LP Consulting Engineers, Inc.

June 5, 2013

Project: VA Building 24, Seismic Correction & Addition
Subject: Addendum Items

MH103A

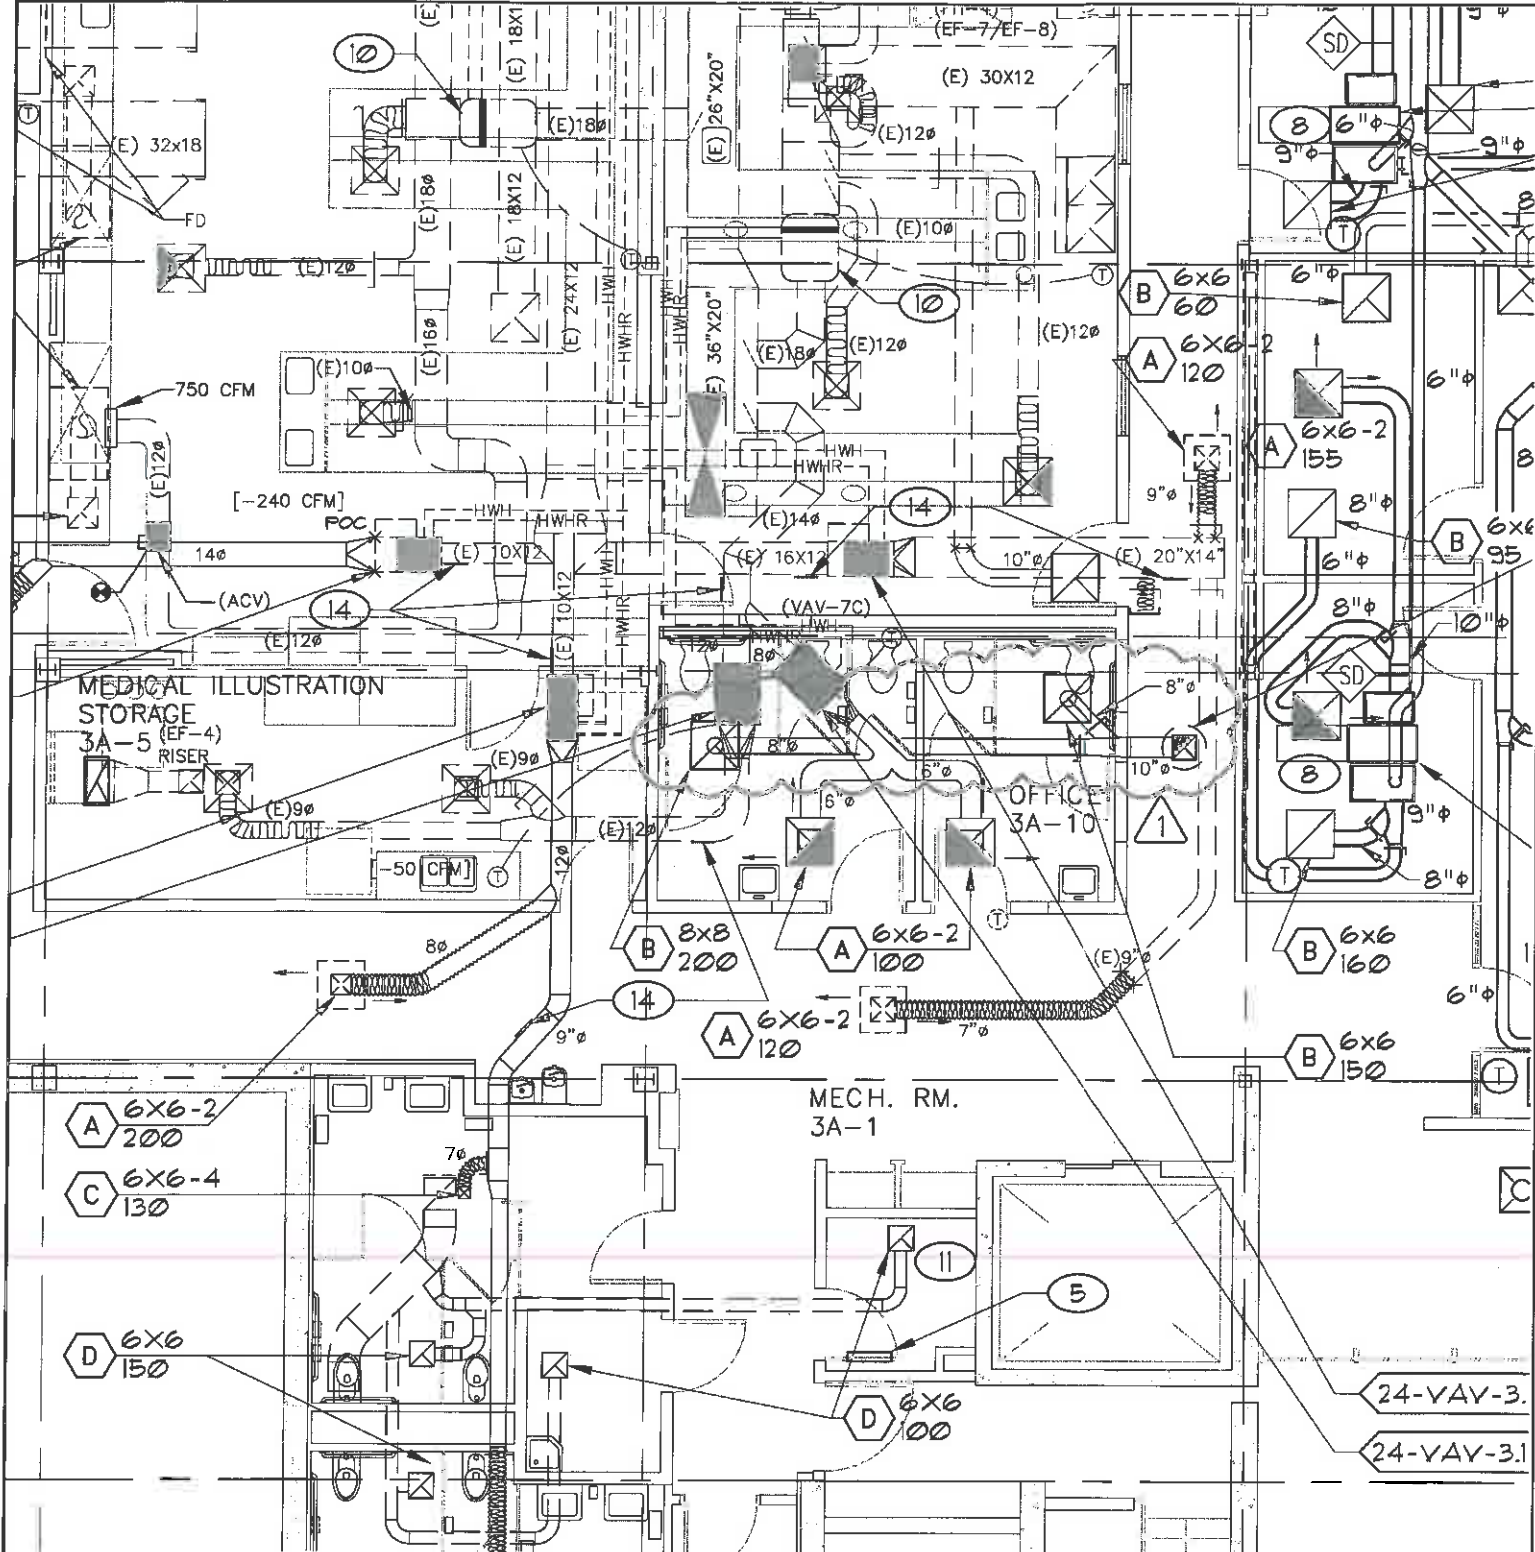
7. Sheet MH103: Omit Keynote 11, new 1-Ton split system not required.
8. Sheet MH103: Relocate 24-EF-1 and revise ductwork as shown on attached Addendum drawing MH103A to avoid conflict with existing solar panels, coordinate exact location in field.

SHEET NO:
MH104A

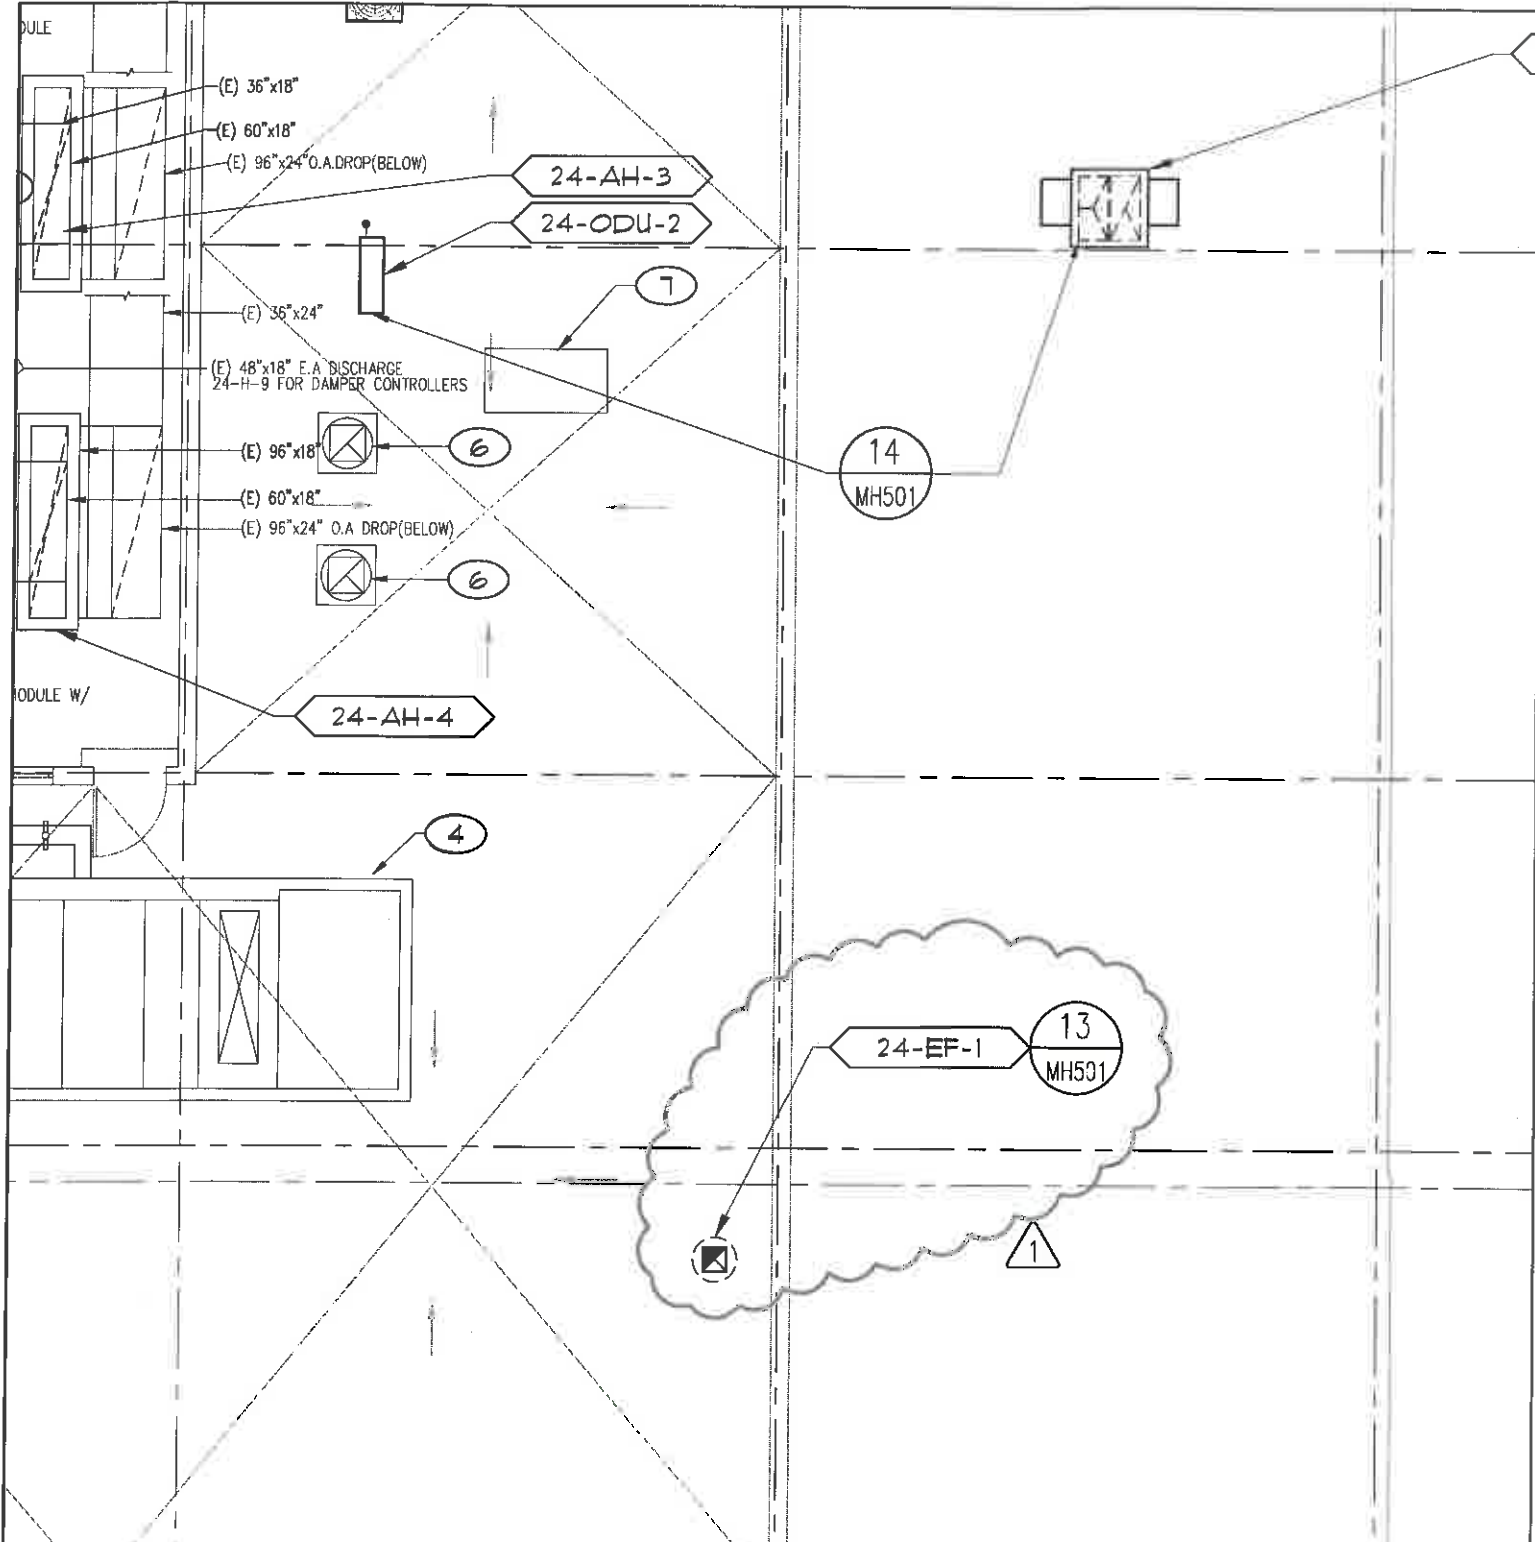
9. Sheet MH104: Relocate 24-EF-1 as shown on attached Addendum drawing MH104A to avoid conflict with existing solar panels, coordinate exact location in field.
